## PCN – Process Change Notification

Change:	FXUB70.A.07.C.001
Date:	2017/04/27
Author	Haley Tsai

Model#	Part Number	Changes
FXUB70.A.07.C.001	Ultra Wide Band Flex MIMO Antenna 698MHz to 3GHz with 150mm 1.37 IPEX MHFI	1. Amend Package Rule.

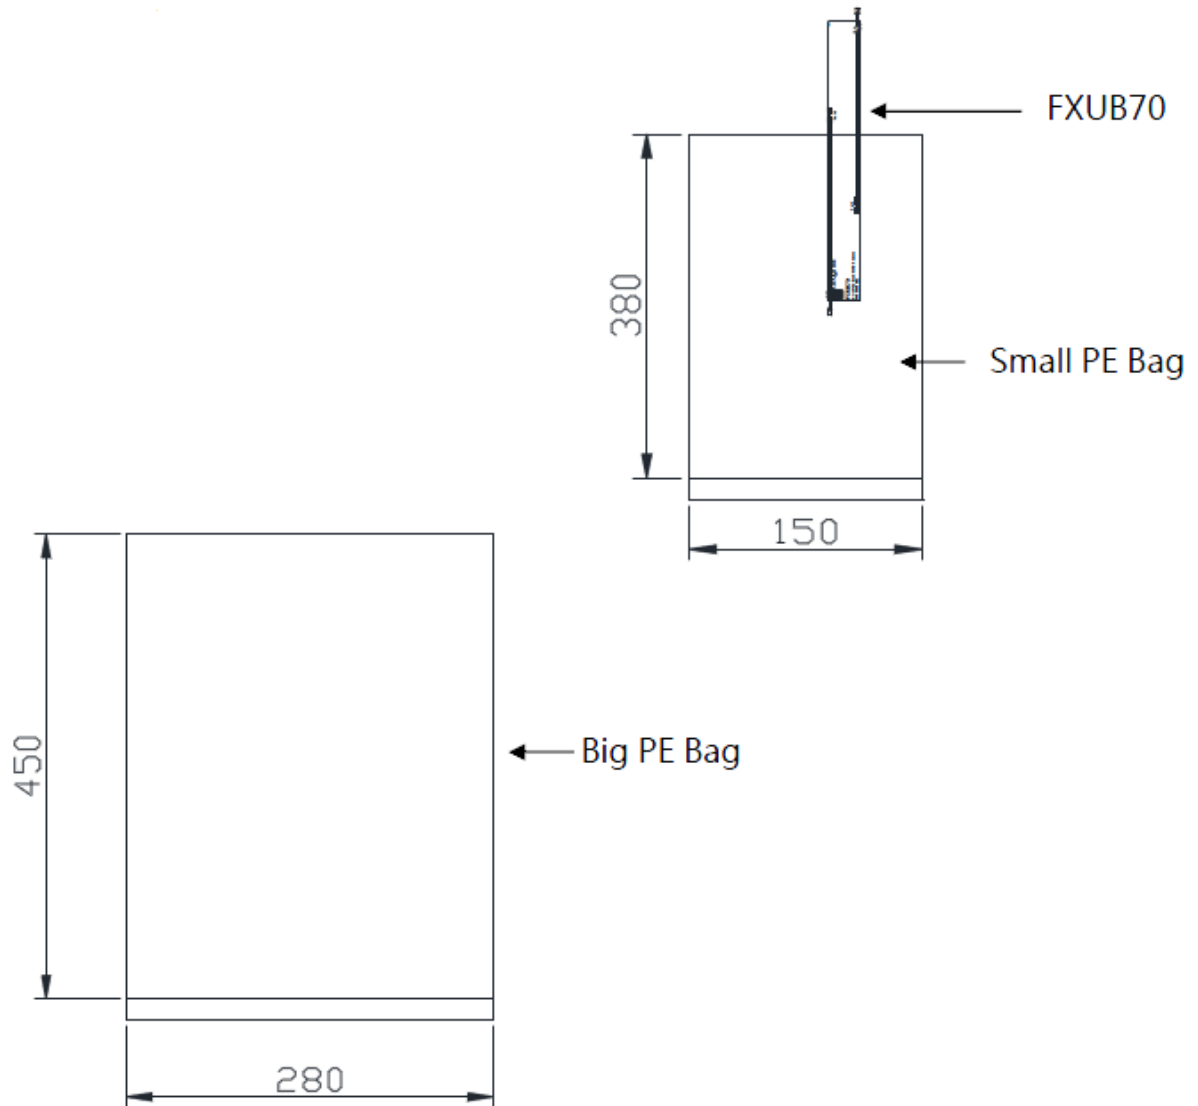
1. Amend Package Rule.

2017, May, Taoglas will provide new package rule into production.
